SUBJECT: BOARD OF CURATORS OF THE UNIVERSITY OF MISSOURI – ISSUANCE OF AMENDMENT NO. 23 TO RENEWED FACILITY OPERATING LICENSE NO. R-79 FOR THE MISSOURI UNIVERSITY OF SCIENCE AND TECHNOLOGY RESEARCH REACTOR TO CHANGE ADMINISTRATIVE CONTROLS IN THE TECHNICAL SPECIFICATIONS TO REFLECT REORGANIZATION OF THE DEPARTMENT OF NUCLEAR ENGINEERING AND RADIATION SCIENCE (EPID NO. L-2020-NFA-0014)

AMENDMENT TO RENEWED FACILITY OPERATING LICENSE

Amendment No. 23  
License No. R-79

SAFETY EVALUATION BY THE OFFICE OF NUCLEAR REACTOR REGULATION

Figure 6.1 Organizational structure of the University of Missouri related to the Missouri S&T Nuclear Reactor Facility

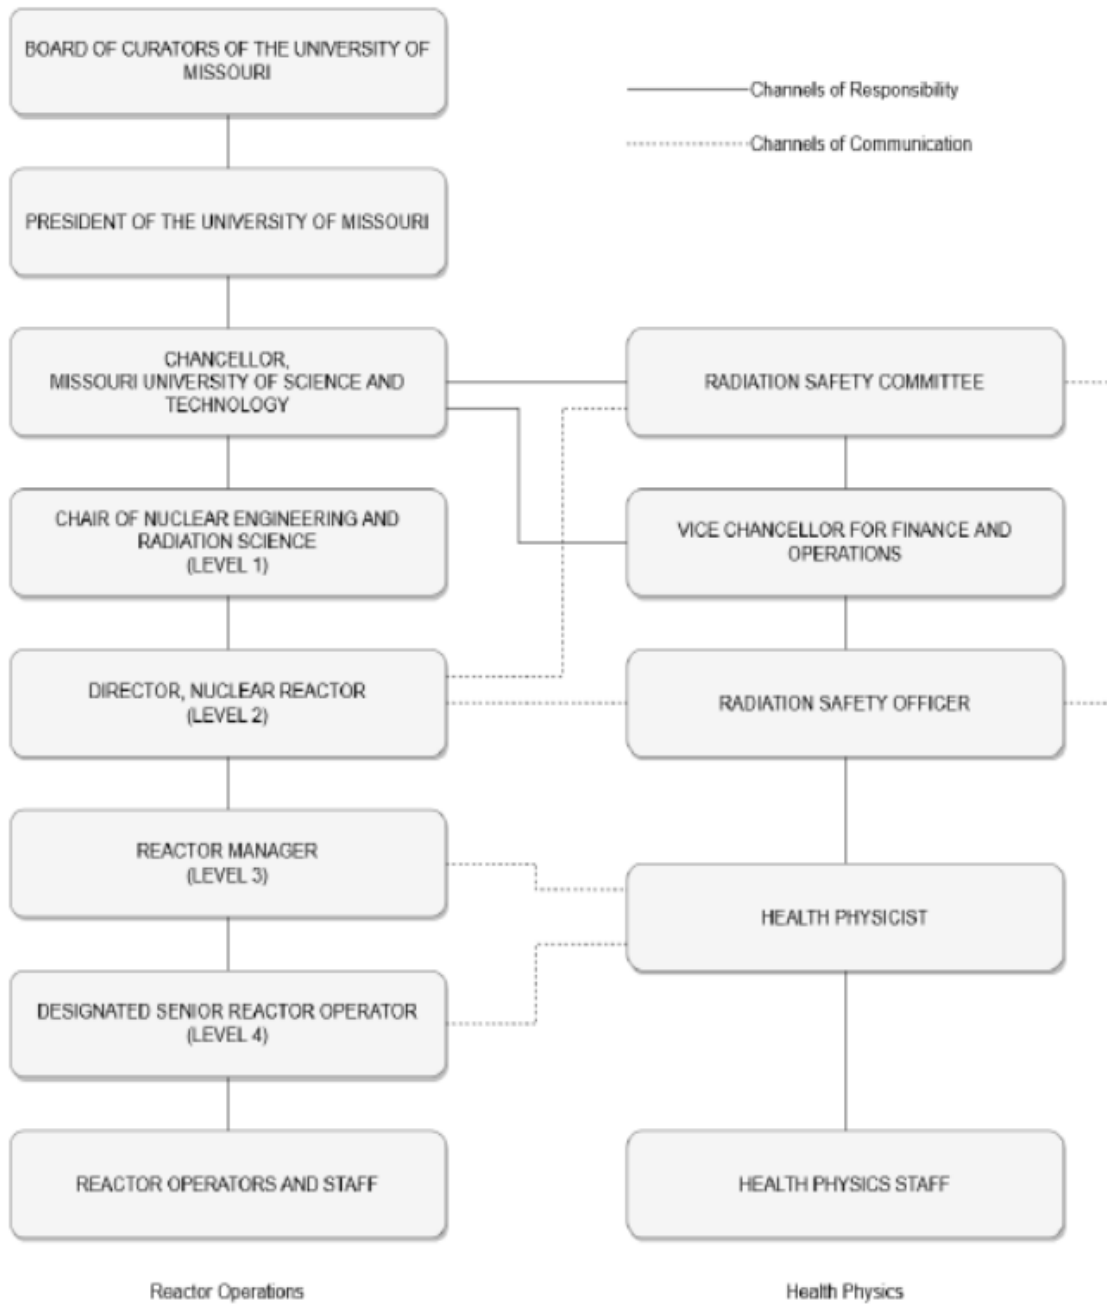
The U.S. Nuclear Regulatory Commission (NRC) has issued the enclosed Amendment No. 23 to Renewed Facility Operating License No. R-79 for the Missouri University of Science and Technology Research Reactor. The amendment modifies technical specification (TS) 6.1, "Organization," in response to the application dated December 2, 2020 (Agencywide Documents Access and Management System Accession No. ML20337A162). Specifically, the amendment revises TS 6.1.1, "Structure," to include the new department name of the Department of Nuclear Engineering and Radiation Science and changes the title for the Level 1 person specified in TS 6.1.2, "Responsibility." The amendment also changes TS Figure 6.1, "Organizational Structure of the University of Missouri related to the Missouri S&T Nuclear Reactor Facility," to reflect the department name change from "Administrative Services" to "Finance and Operations." Additionally, the amendment makes minor format and punctuation changes in TS Figure 6.1.

Figure 6.1 Organizational structure of the University of Missouri related to the Missouri S&T Nuclear Reactor Facility

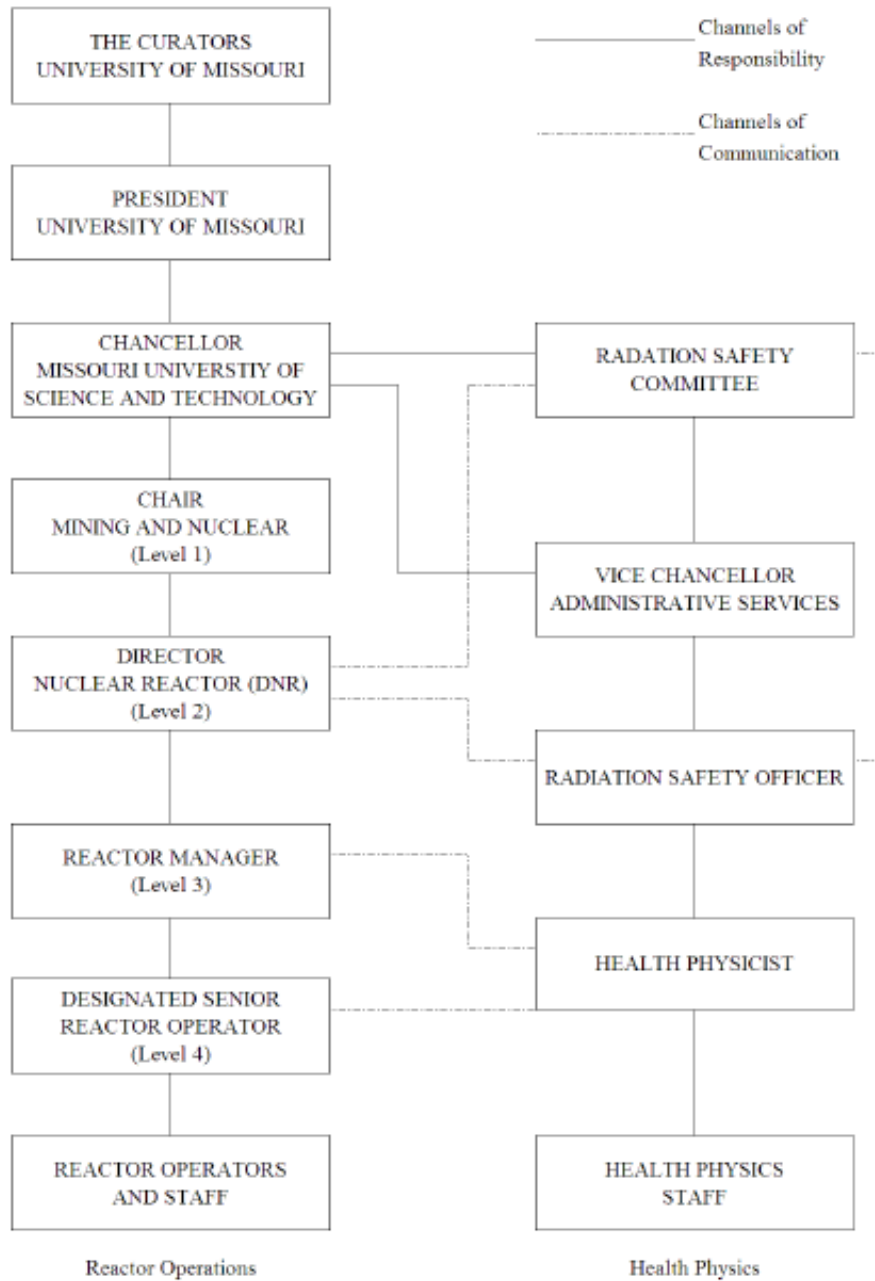
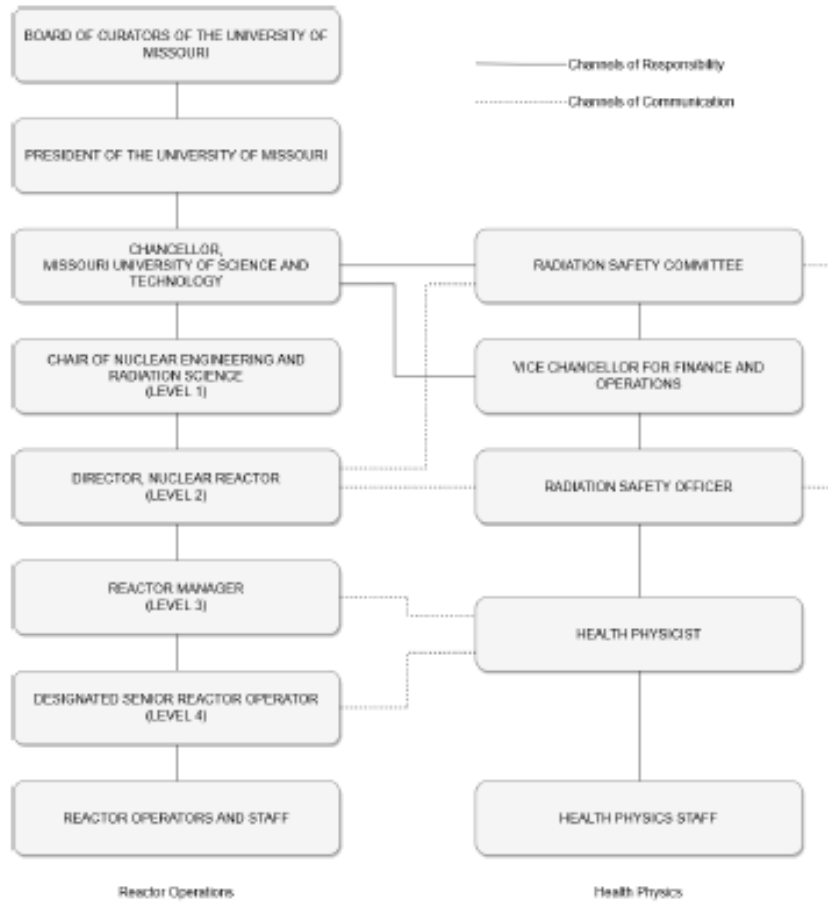
The licensee proposed several changes to TS Figure 6.1 to reflect the new names in the organizational structure:

- Change the name of the licensee from “The Curators University of Missouri” to “Board of Curators of the University of Missouri” to be consistent with the name of the licensee in Section I.A. of Renewed Facility Operating License No. R-79 and as specified in the definition of “licensee” in TS 1.2, “Definitions.”
- Change the name of the Level 1 administrator from “Chair Mining and Nuclear” to “Chair of Nuclear Engineering and Radiation Science.”
- Delete “Vice Chancellor Administration Services” and replace it with “Vice Chancellor for Finance and Operations.”
- Delete “(DNR)” from the Level 2 administrator’s title of “Director Nuclear Reactor.”

The NRC staff evaluated the proposed changes using the guidance in ANSI/ANS-15.1-2007, Section 6.1, which states that the functions, assignments, and responsibilities shall be specified in the TSs. The NRC staff finds that the proposed updated organizational names do not alter the responsibilities and structure of the operating organization. The NRC staff also finds that the proposed changes to TS Figure 6.1 are to the positions or titles of officers or organizational

units of the licensee and are consistent with ANSI/ANS-15.1-2007, Section 6, in that the TSs continue to specify the required licensee organizational structure and management responsible for reactor facility operations. Therefore, the NRC staff concludes that changing the above organizational names in TS Figure 6.1 is acceptable.
